<b>Project:</b>	2022-RFT-026 821131 – Solid Waste WTS Construction		
<b>Addendum No.</b>	06	<b>No. of Pages:</b>	5
<b>Date:</b>	2022-08-17	<b>Doc. No.:</b>	P7201-1591092266-188(1.0)

The purpose of this Addendum is to clarify and answer for bidder's question on tender 2022-RFT-026 issued for bid on July 12, 2022.

1 HVAC LAYOUT - PLANT  
M02 1:125

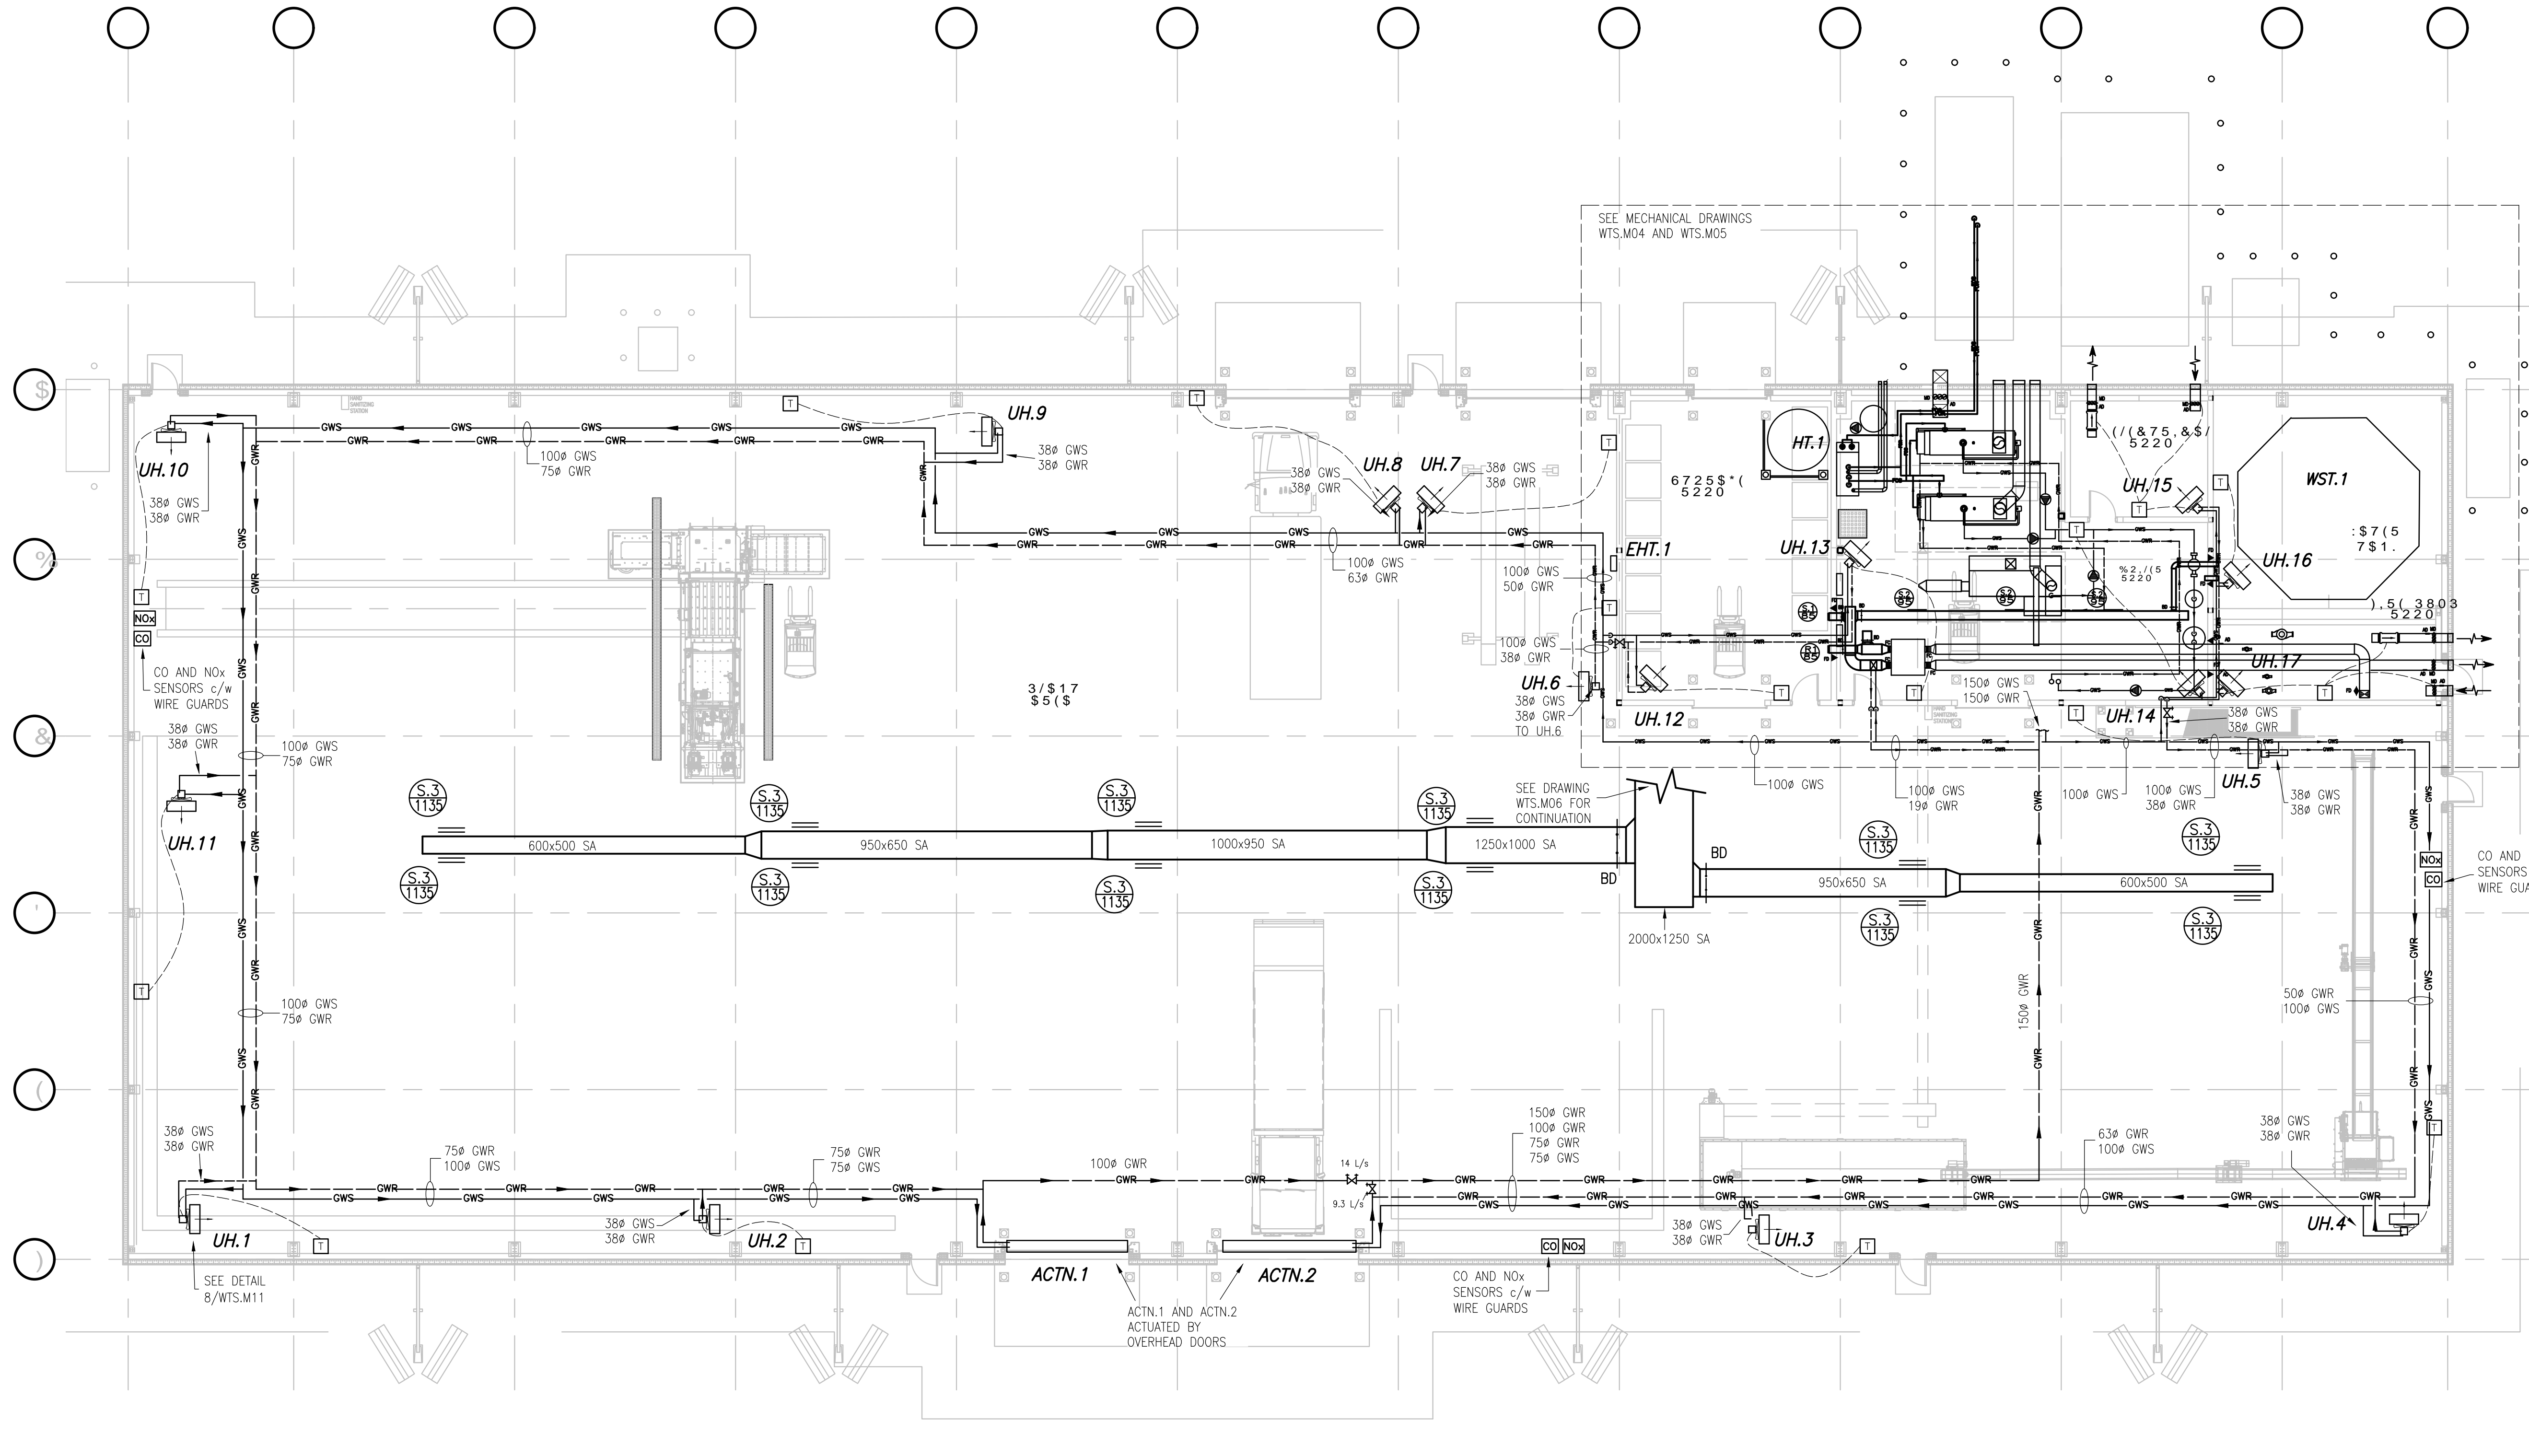
### **Drawing WTS.M02 – MECHANICAL LAYOUT – HVAC**

1. Replace existing drawing WTS.M02 rev 9 with attached rev 10 (enclosed).
2. Add NOx sensors c/w wire guards as shown.
3. Revise GWR piping as shown.
